2004.07.30 Hw
minor
mod

Re: Minor Modification for re-configuring piping
EPA I.D. No: NYD002014595
DEC Part 373/Air Permit No.3-3340-00027/4-0
Cohoes (C), Albany County

Re: Norlite Corporation
6 NYCRR Part 373 Permit No. 4-0103-16/16-0
6 NYCRR Part 373 Minor Permit Modification-reconfigure piping
for permitted hazardous waste tanks

The following modifications involve changes to the piping of the permitted hazardous waste storage tanks 335-300, 400, 500 & 600 (outside tanks). The revised drawings reflect the following changes:

DATE: 04/29/02
 FILE NAME: NY003-1317-HI
 DRAWING NO: NY003-1317

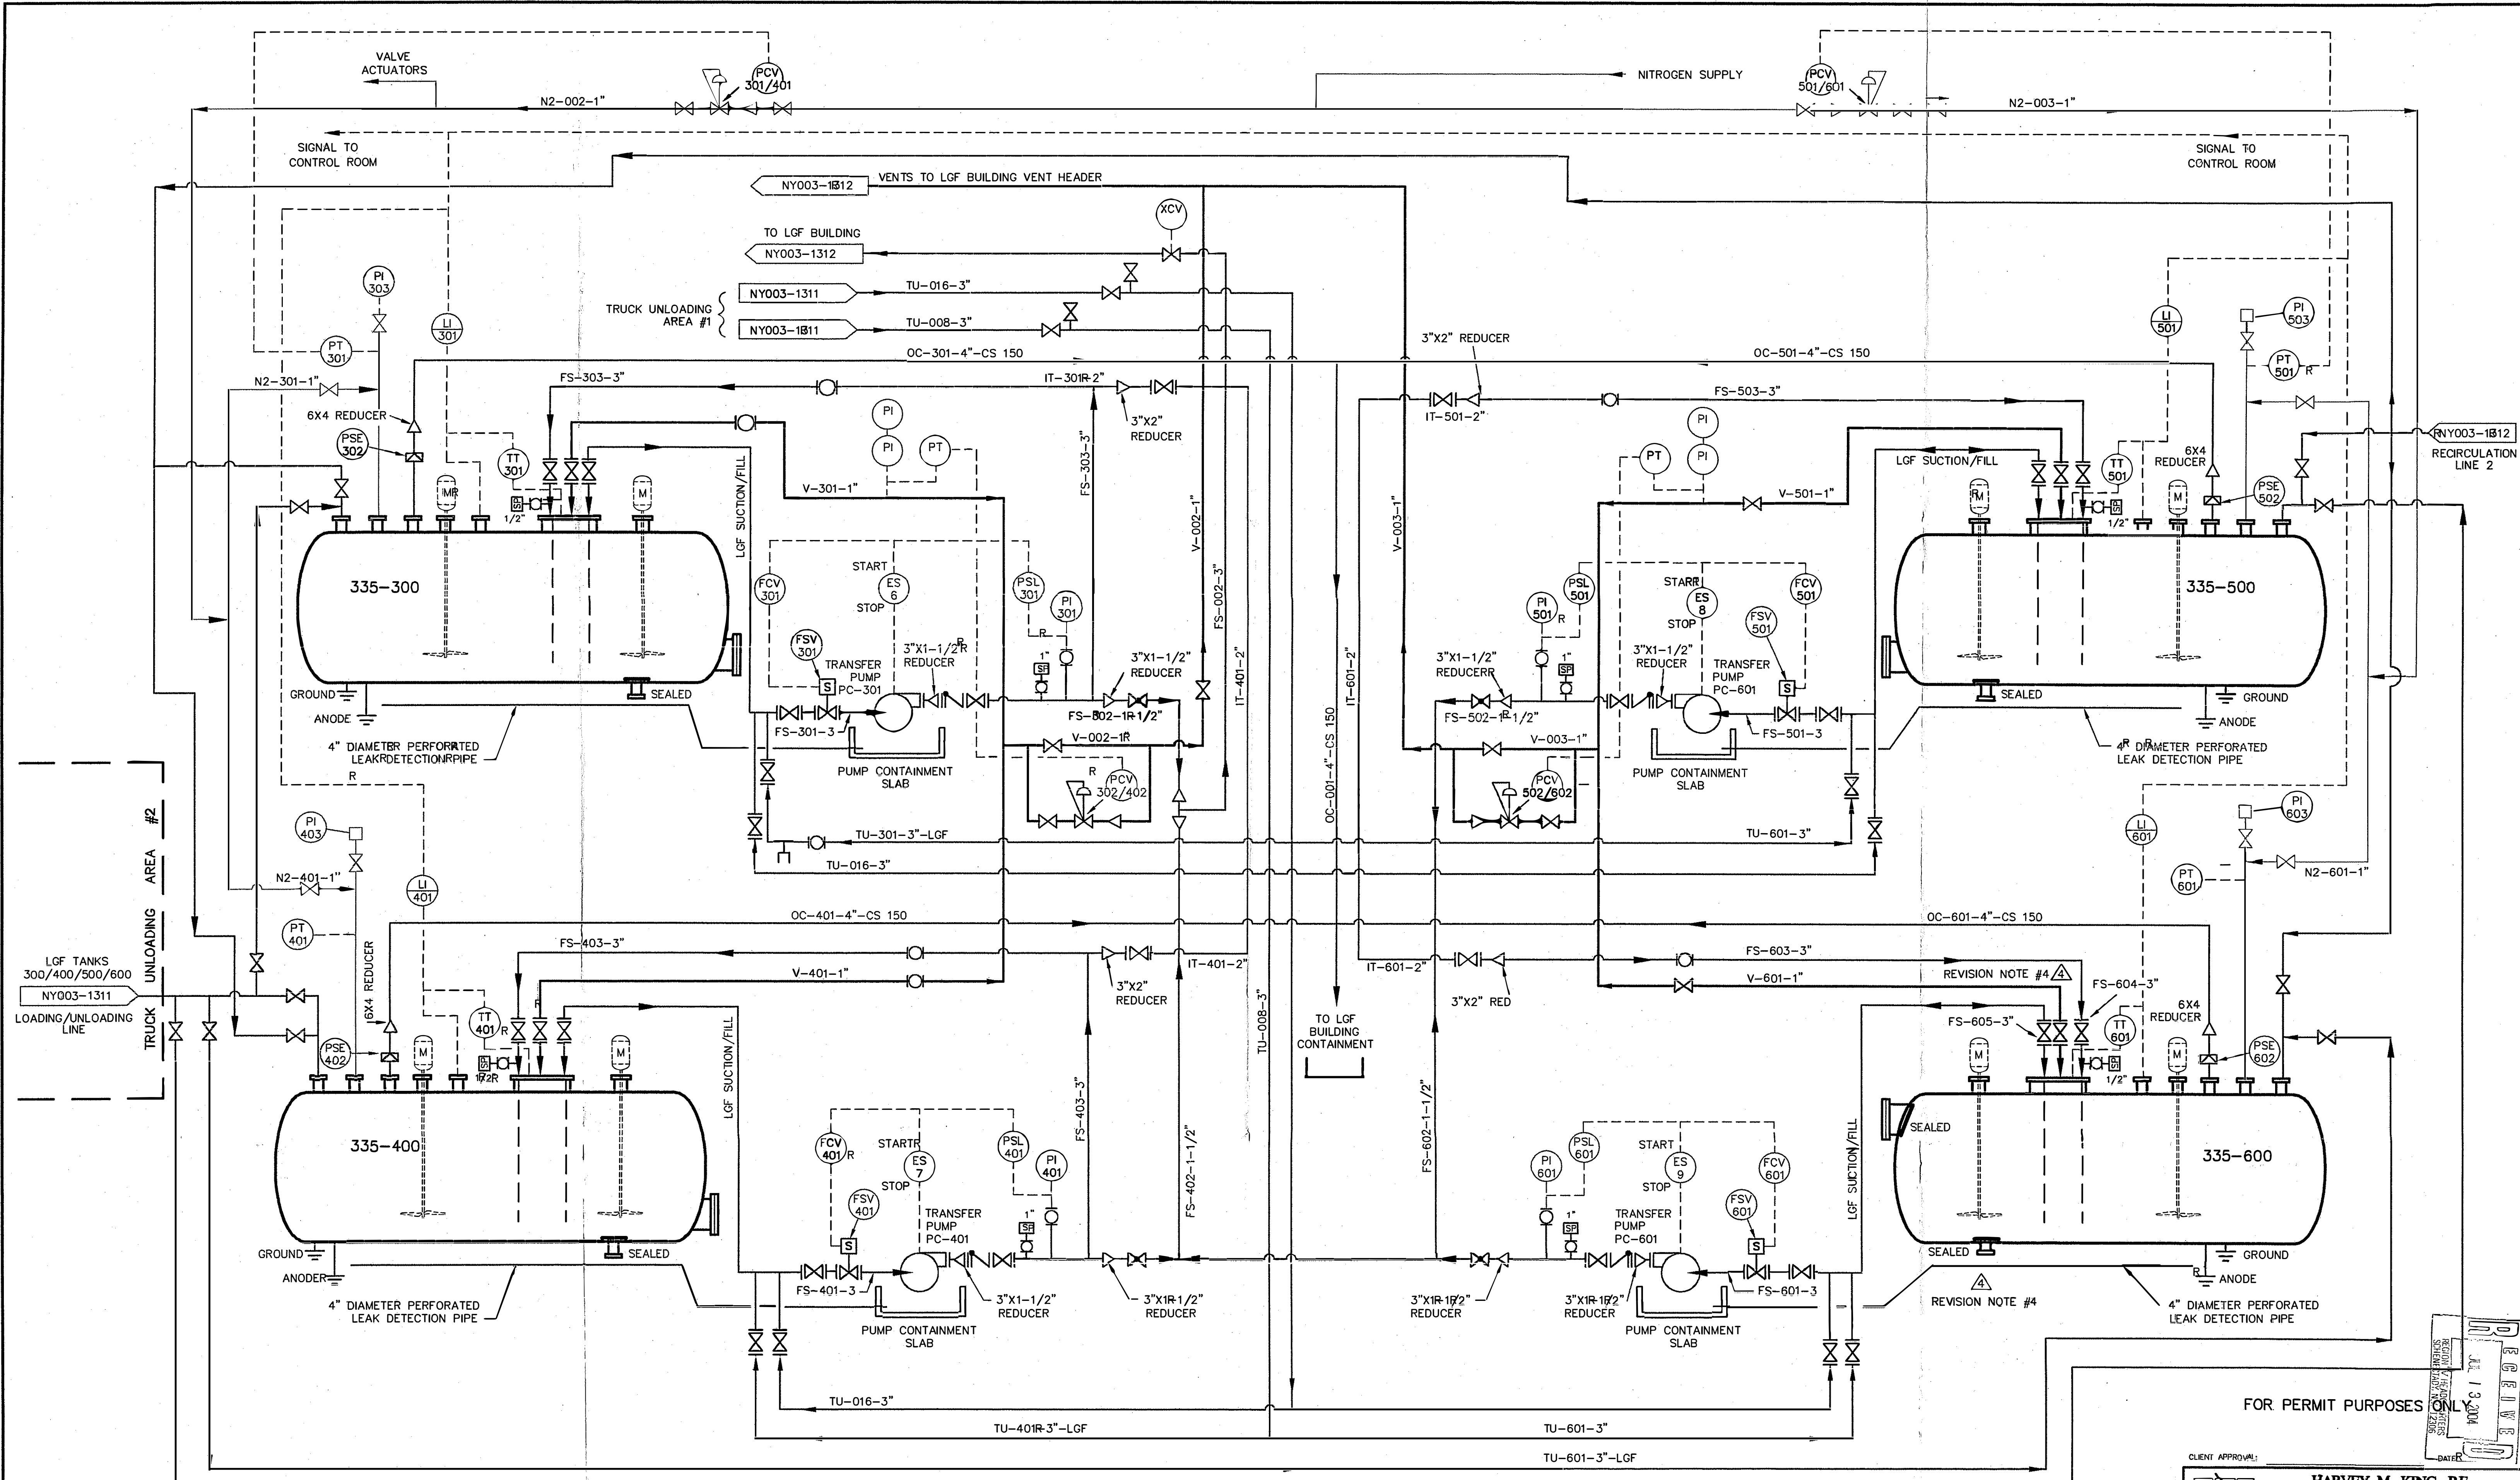
- The installation of new piping, valves and tank nozzles will allow Norlite to unload directly from Unloading Area #2 to the outside tanks. These modifications are shown on drawings: NY003-1317, NY003-5432, NY003-5433 and NY003-5434.

- The installation of new piping, valves and tank nozzles, as well as modifications of existing piping, will facilitate the recirculation of LGF from the kiln burners back to the outside tanks. The recirculation will only occur after the agitators have been installed as per the modification approved on April 20, 2004. These modifications are shown on drawings: NY003-1312, NY003-1314, NY003-1315, NY003-1317, NY003-5432 and NY003-5433.
